UNITED STATES PATENT AND TRADEMARK OFFICE

APPLICATION NO.	FILING DATE	FIRST NAMED INVENTOR	ATTORNEY DOCKET NO.	CONFIRMATION NO.
10/671,842	09/25/2003	Michael D. Brookshire	121236.00003	9648
26707	7590	12/26/2007	EXAMINER	
QUARLES & BRADY LLP			REESE, DAVID C	
RENAISSANCE ONE			ART UNIT	
TWO NORTH CENTRAL AVENUE			PAPER NUMBER	
PHOENIX, AZ 85004-2391			3677	
			MAIL DATE	DELIVERY MODE
			12/26/2007	PAPER

Office Action Summary	Application No. 10/671,842	Applicant(s) BROOKSHIRE, MICHAEL D.	
	Examiner David C. Reese	Art Unit 3677

DETAILED ACTION

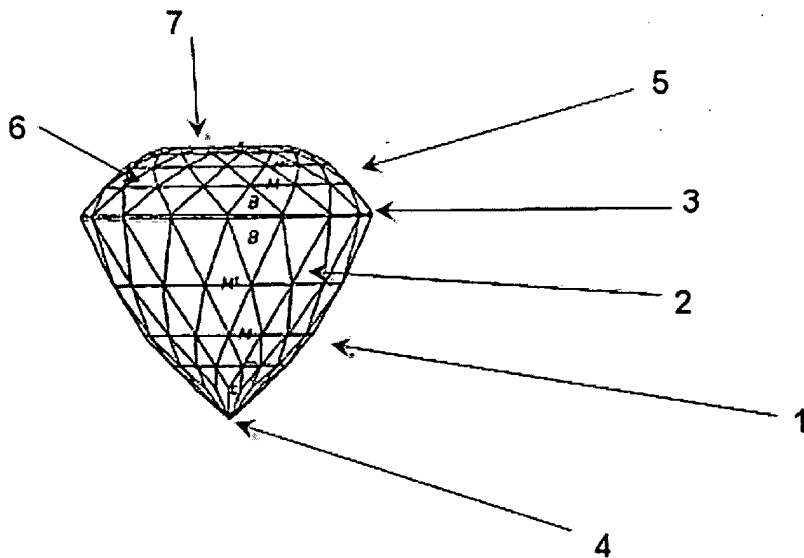
As for Claim 40, Diagrams for Faceting reference discloses of a cut gemstone (see figure 9), comprising:

a pavilion (1) having a plurality of facets (2) disposed from a girdle (3) to a culet (4); and
a dome-shaped crown (5) disposed above the girdle (3), wherein the girdle (3) extends no further than a widest circumference (bottom of 5) of the dome-shaped crown (5) and the pavilion (1) extends no further than a widest circumference of the girdle (3), the dome-shaped crown (5) formed from a plurality of sets of facets (6) cut with monotonically decreasing angles to form a curved contour in accordance with a dome shape from the girdle (3) to an apex (7) of the dome-shaped crown (5), each facet (6) within the sets of facets (6) being polygonal in shape with opposing corners of the polygon nested between adjacent facets (6).

Re: Claim 44, wherein the dome-shaped crown (5) is formed from at least five sets of facets (6) (see also figure ID on page 9 of "Diagrams") with monotonically decreasing angles to form the curved contour in accordance with the dome shape (5).

As for Claim 47, Diagrams for Faceting reference discloses of a cut gemstone (see figure below), comprising:

a pavilion (1) having a plurality of facets (2) disposed from a girdle (3) to a culet (4); and
a dome-shaped crown (5) disposed above the girdle (3), wherein the girdle (3) extends no further than a widest circumference (bottom of 5) of the dome-shaped crown (5) and the pavilion (1) extends no further than a widest circumference of the girdle (3), the dome-shaped crown (5) formed from a plurality of sets of facets (6) cut with monotonically decreasing angles to form a curved contour in accordance with a dome shape from the girdle (3) to an apex (7) of the dome-shaped crown (5).

Re: Claim 48, wherein each facet (6) within the sets of facets (6) is polygonal in shape with opposing corners of the polygon nested between adjacent facets (6).

Re: Claim 54, wherein the dome-shaped crown (5) is formed from at least five sets of facets (6) (see also figure ID on page 9 of "Diagrams") with monotonically decreasing angles to form the curved contour in accordance with the dome shape (5).

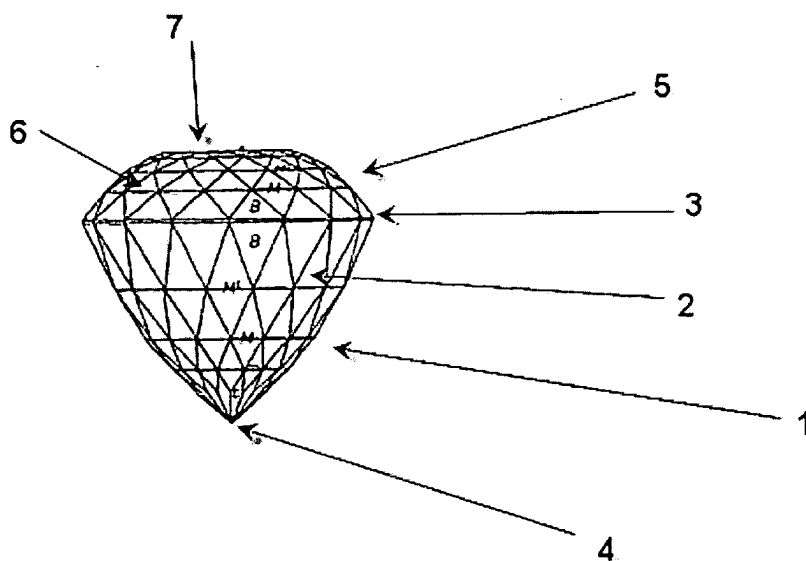
As for Claim 1, Diagrams for Faceting reference teaches of a diamond (see figure below), comprising:

a pavilion (1) having a plurality of facets (6) disposed from a girdle (3) to a culet (4), each of the plurality of facets (6) having a continuous flat surface extending from the girdle (3) to the culet (4), wherein an edge of a first adjoining facet contacts an edge of a second adjoining facet along a common radial boundary; and

a dome-shaped crown (5) disposed above the girdle (3), wherein the girdle (3) extends no further than a widest circumference (bottom of 5) of the dome-shaped crown (5) and the pavilion (1) extends no further than a widest circumference of the girdle (3), the dome-shaped crown (5)

formed from at least five sets of facets (6) with monotonically decreasing angles to form a curved contour in accordance with a dome shape from the girdle (3) to an apex (7) of the dome-shaped crown (5), each facet (6) within the sets of facets (6) nested between adjacent facets (6), each of the sets of facets (6) having monotonically decreasing surface area from the girdle (3) to the apex (7) of the dome-shaped crown (5).

The difference between the claim and “Diagrams” is that “Diagrams” does not expressly disclose that each facet (6) within the set of facets (6) being hexagonal in shape; and that the apex (7) of the dome-shaped crown (5) has less surface area than each facet (6) from the sets of facets (6). It would have been an obvious matter of design choice to modify “Diagrams” (the aspect of the shape of the facets within the sets of facets, and of the apex having less surface area than each facet within the sets of facets) since applicant has not disclosed that such a particular

As for Claim 13, "Diagrams" teaches of a diamond (see figure above), comprising:

a pavilion (1) extending from a girdle (3) to a culet (4), wherein the girdle (3) extends no further than a widest circumference of the crown (5) and the pavilion (1) extends no further than a widest circumference of the girdle (3); and

a crown (5) in the form of a symmetrical hemisphere formed from at least five sets of facets (6) between the girdle (3) and an apex (7) of the crown (5) having a first set of facets (6) disposed above the girdle (3) and a second set of facets (6) disposed between the first set (6) of facets and an apex (7) of the crown (5), wherein the first set of facets (6) is cut at a first angle with respect to a reference line which is tangential to the apex (7) of the crown (5) and the second set of facets (6) is cut at a second angle with respect to the reference line which is less than the first angle, each facet (6) within the first and second sets of facets (6) being hexagonal in shape with opposing corners of the hexagon nested between adjacent facets (in view of remarks above).

As for Claim 23, “Diagrams” teaches of a diamond (see figure above), comprising:
a pavilion (1) having a plurality of facets (2) disposed from a girdle (3) to a culet (4); and
a dome-shaped crown (5) disposed above the girdle (3), wherein the girdle (3) extends no further than a widest circumference of the dome-shaped crown (5) and the pavilion (1) extends no further than a widest circumference of the girdle (3), the dome-shaped crown (5) formed from

a at least five sets of facets (6) cut with monotonically decreasing angle to form a curved contour in accordance with a dome shape from the girdle (3) to an apex (7) of the dome-shaped crown (5), each facet (6) within the first and second sets of facets (6) being hexagonal in shape with opposing corners of the hexagon nested between adjacent facets (in view of remarks above).
